Office Action Summary

10/773,107

RHODES ET AL.

DETAILED ACTION***Drawings***

Attachment 1

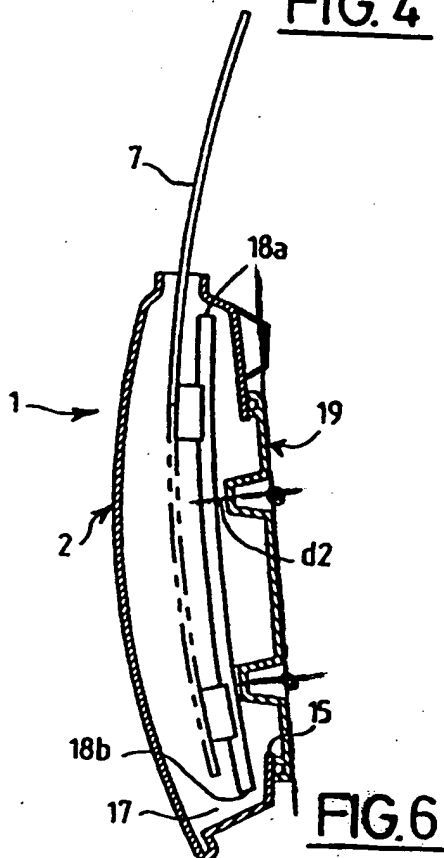
Bertolini et al. disclose a door module with parallel window regulator rails (18), window regulator (5), and a trim panel (19). The window regulator rails (18) can be separably fixed to the trim panel by clips, disclosed on lines 4-6 of column 6. The rails are fastened to the trim panel (19) at upper and lower regions of the rails (18). Specifically, the attachment locations are on folds (12). A line projects perpendicularly from upper fastening point

intersects the plane defined by the trim panel at a point outside the trim panel, as shown the Attachment 1.

*Attachment 2*

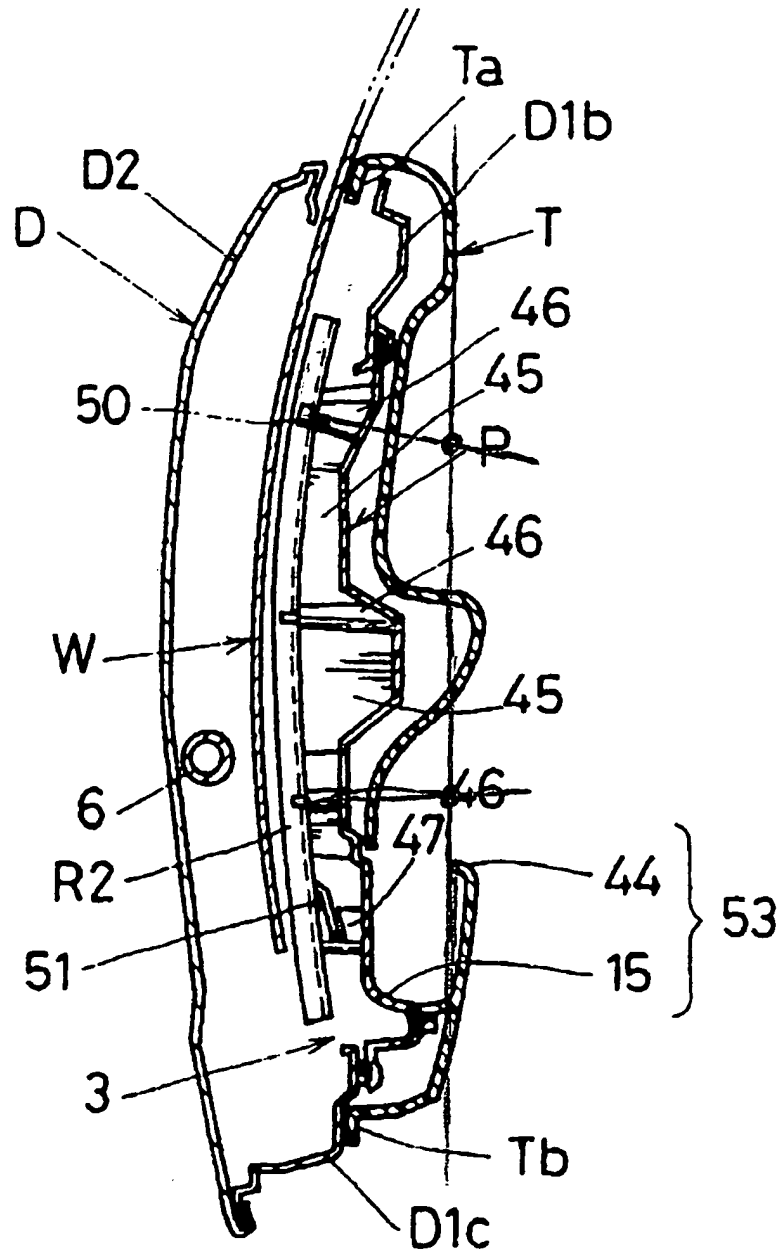
Nishikawa et al. disclose a door module with a window regulator rail (R2), a window regulator (R1), and a trim panel (P). The window regulator rail is separably fixed to the trim panel (P). The rail (R2) is fastened to the upper and lower regions of the trim panel (P). An electric window regulator control (40) is attached to the trim panel (P) and has wires that connect it to the window regulator (R1). A door handle (30) and a lock (33) are detachably mounted to the trim panel (P). A line projects perpendicularly from upper fastening point intersects the plane defined by the trim panel at a point outside the trim panel, as shown the Attachment 2.
